**Bellefonte Nuclear Plant, Units 3 & 4**

**COL Application**

**Technical Specifications**

Section A. PSTS and Bases Differences from the DCD GTS and Bases (BLN COL 16.1-1)

Figure B 3.6.8-1 (page 1 of 1)  
Time Prior to Coolant Inventory Boiling

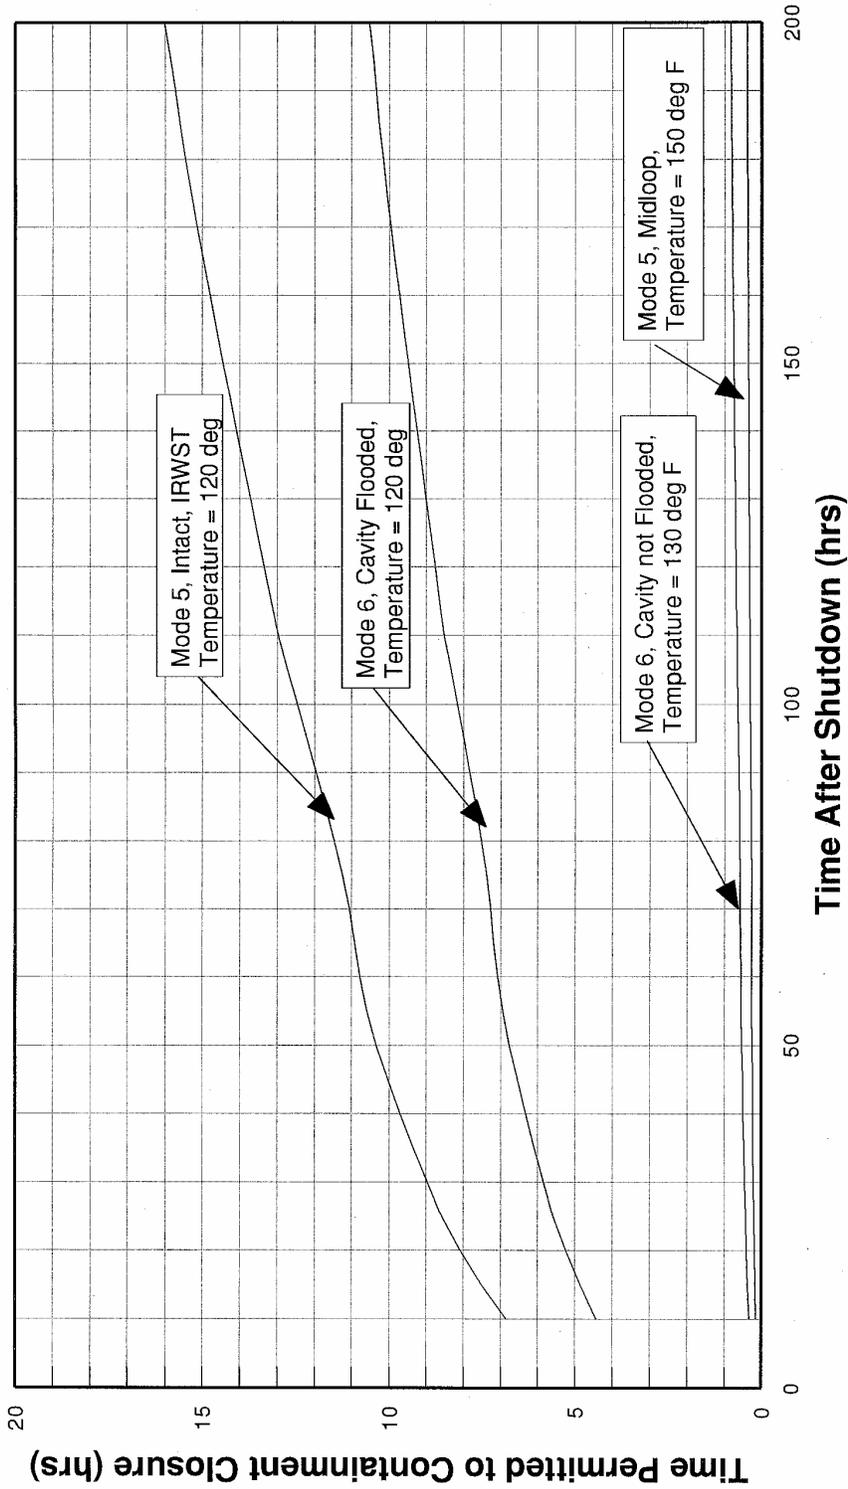
- GTS 3.6.8 Bases Figure B3.6.8-1 contains a bracketed curve identifying the time permitted for containment closure in terms of time after shutdown. The entire figure is bracketed. The plant specific curve needed to replace the bracketed value is determined from final fuel data. Therefore, a Bases change is required to provide a plant specific set of curves to replace the bracketed figure. This Bases change will be completed prior to initial fuel load.

FIGURE 4.1-1 Low Population Zone and Site Boundary Map

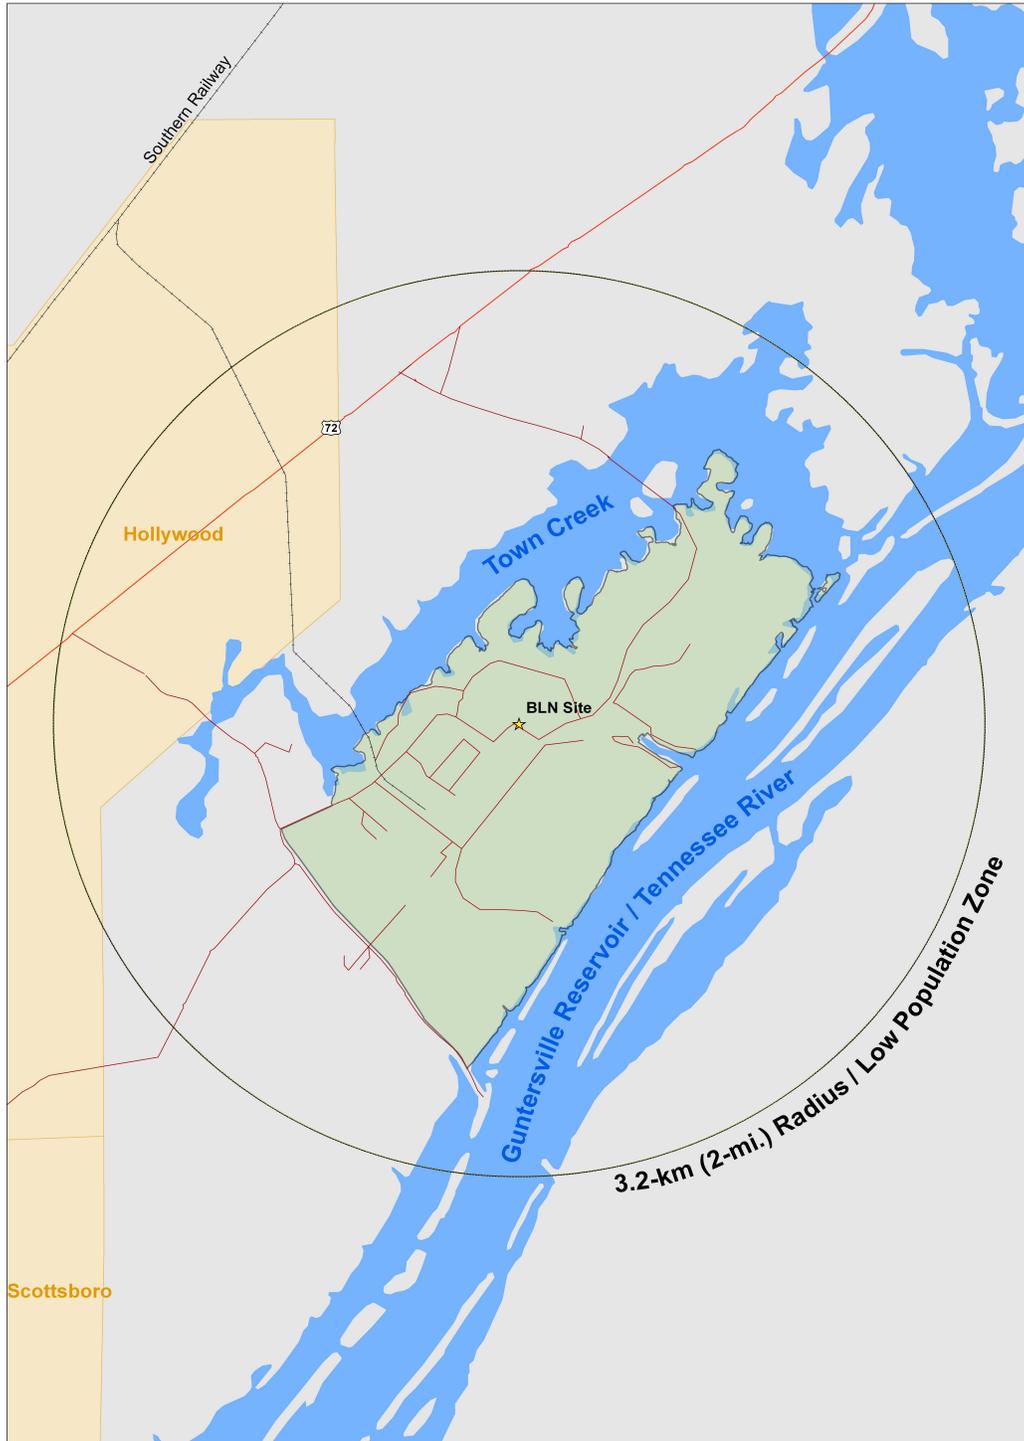
- GTS 4.1.1        The bracketed information in the GTS reads:  
[This information will be provided by the combined license applicant.]
- Replace the bracketed information in the GTS with the following:  
The Site Boundary is shown in Figure 4.1-1. The Exclusion Area Boundary is shown in Figure 4.1-2.

- GTS 4.1.2        The bracketed information in the GTS reads:  
[This information will be provided by the combined license applicant.]
- Replace the bracketed information in the GTS with the following:  
The LPZ is defined by the 2 mile radius from the site center point as shown in Figure 4.1-1.
